**RANGELINE BUSINESS PARK SUBDIVISION,**  
**UNIT TWO, RESUBDIVISION OF LOTS 13, 14 & 15**

APPLICATION NUMBER 4 DATE December 19, 2013

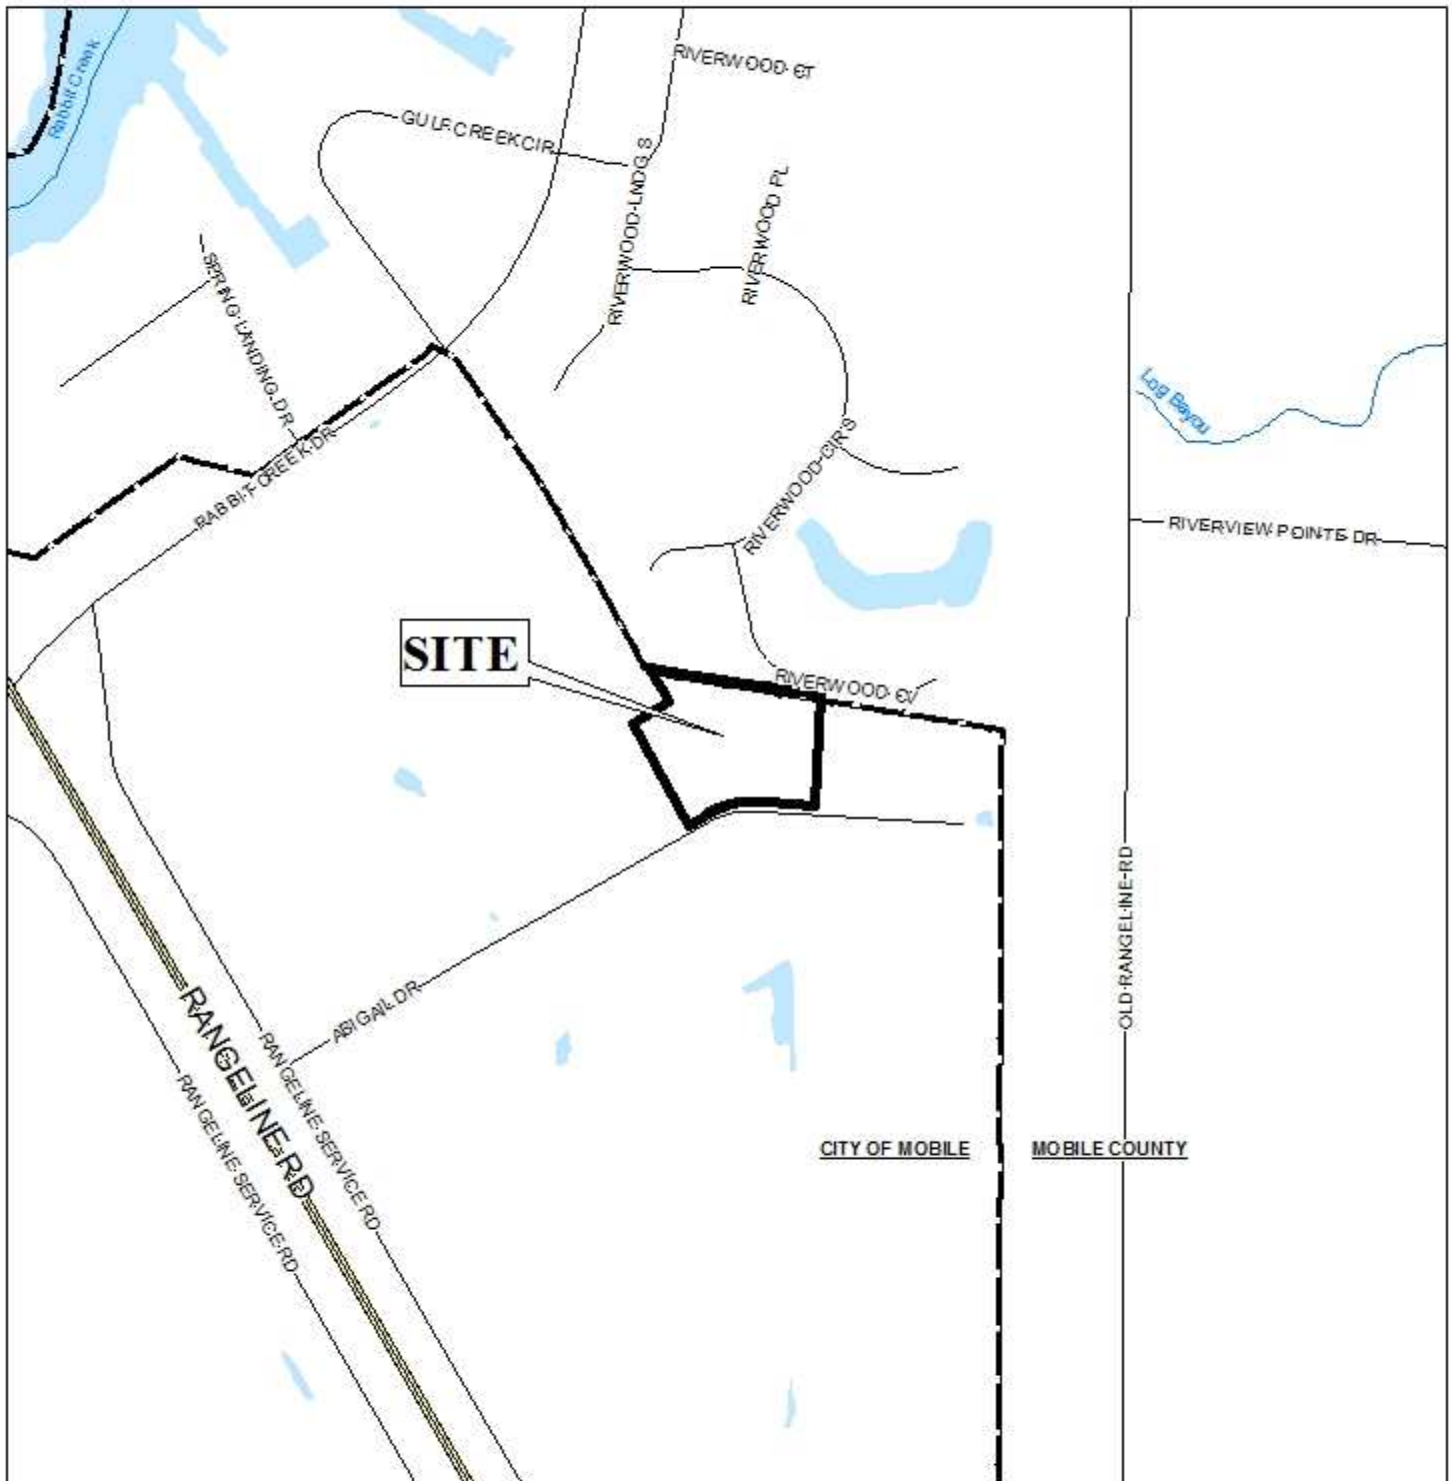
Both lots would front Abigail Drive, the right-of-way width of which is not indicated on the plat. As the recorded plat of Rangeline Business Park, Unit Two, indicates a 50' right-of-way, the plat should be revised to indicate a 50' right-of-way for Abigail Drive. As a means of access management, a note should be required on the Final Plat stating that each lot is limited to one curb cut to Abigail Drive, with the size, location, and design to be approved by Traffic Engineering and conform to AASHTO standards.

The 25-foot minimum building setback line is depicted on the preliminary plat, and this should be retained on the Final Plat.

There is a common area at the East terminus of Abigail Drive recorded with Rangeline Business Park, Unit Two. As on that recorded plat, a note should be required on the Final Plat stating that the maintenance of all common areas and common detention facilities is the responsibility of the property owners. There is a small portion of a drainage easement at the Northwest corner of proposed Lot A; therefore, a note should be required on the Final Plat stating that no structures may be constructed within the drainage easement.

This is a commercial site and is adjacent to residential use to the North outside the City limits. Therefore, a note should be placed on the Final Plat stating that a buffer, in compliance with Section V.A.8. of the Subdivision Regulations, will be required along the North side upon the development of any lot.

- 1) retention of the lot sizes in both square feet and acres, or the furnishing of a table on the Final Plat providing the same information;
- 2) revision of the plat to indicate the right-of-way width of Abigail Drive;

- 3) placement of a note on the Final Plat stating that each lot is limited to one curb cut to Abigail Drive, with the size, design, and exact location of all curb cuts to be approved by Traffic Engineering and conform to AASHTO standards;

- 4) retention of the 25' building setback line along Abigail Drive;
- 5) placement of a note on the Final Plat stating that maintenance of all common areas and common detention facilities is the responsibility of the property owners;

- 6) placement of a note on the Final Plat stating that no structures may be constructed within the drainage easement at the Northwest corner of Lot A;

- 7) placement of a note on the Final Plat stating that a buffer, in compliance with Section V.A.8. of the Subdivision Regulations, will be required along the North side upon development of any lot;
